DEVELOPMENT APPLICATION ASSESSMENT REPORT

Application Number:	DA2025/0489
----------------------------	-------------

Responsible Officer:	Brittany Harrison
Land to be developed (Address):	Lot 43 DP 13457, 138 Prince Alfred Parade NEWPORT NSW 2106
Proposed Development:	Alterations and additions to a dwelling house including a garage and studio
Zoning:	C4 Environmental Living
Development Permissible:	Yes
Existing Use Rights:	No
Consent Authority:	Northern Beaches Council
Land and Environment Court Action:	No
Applicant:	Jamie Morton Calder Emily Claire Wilcox

Figure 1: Amended Plans - Building Envelope encroachment (shaded red), existing garage outline (shown in red dashed outline).

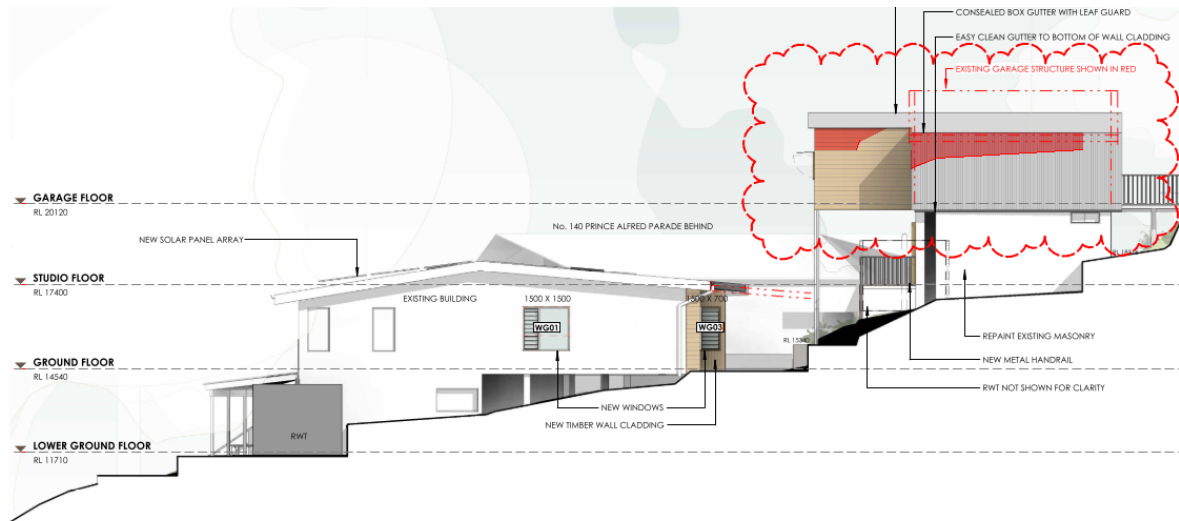
Clause D10.11 Building Envelope generally requires development to be sited within a 3.5m building envelope to ensure the bulk and scale of the built form is minimised.

The portion of the proposed garage and workshop/storage extension will be located outside of the prescribed building envelope to the southern elevation (Figure 1).

Figure 2: Initial Plans - Building Envelope encroachment (shaded red).

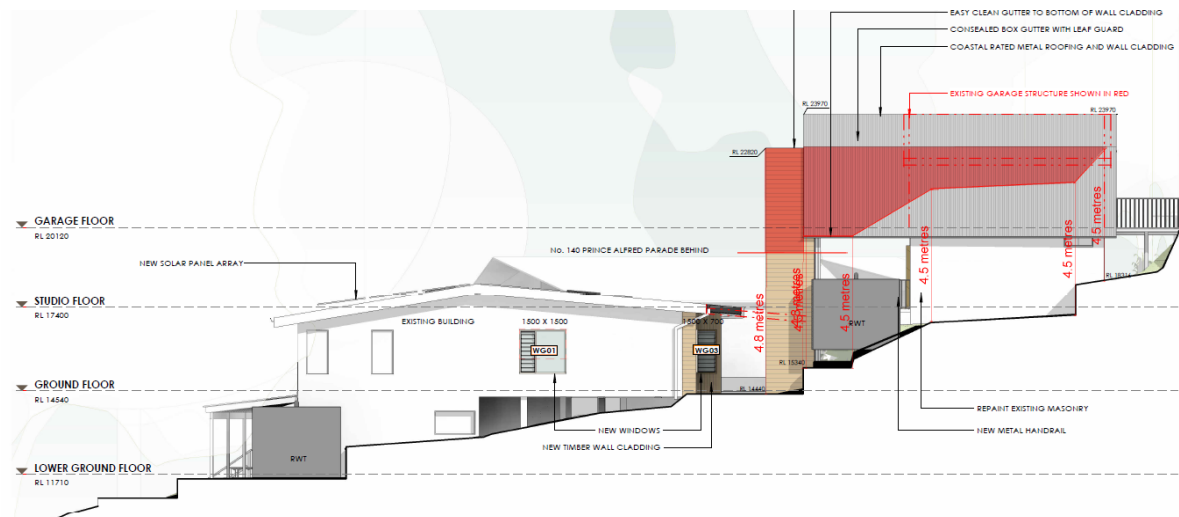
It is noted that the design was amended in which significantly reduced the initial proposed breach, and the deletion of a lift structure that was contributing to excessive visual dominance (Figure 2). It is also noted that the bulk and scale of the garage structure is similar in scope and form to that of adjoining structures, which are positioned and designed with a similar building bulk. Furthermore, it is noted that when viewed from the street, the garage is of lower height that the existing garage, allowing for view corridors towards the rear and adjoining waterway.
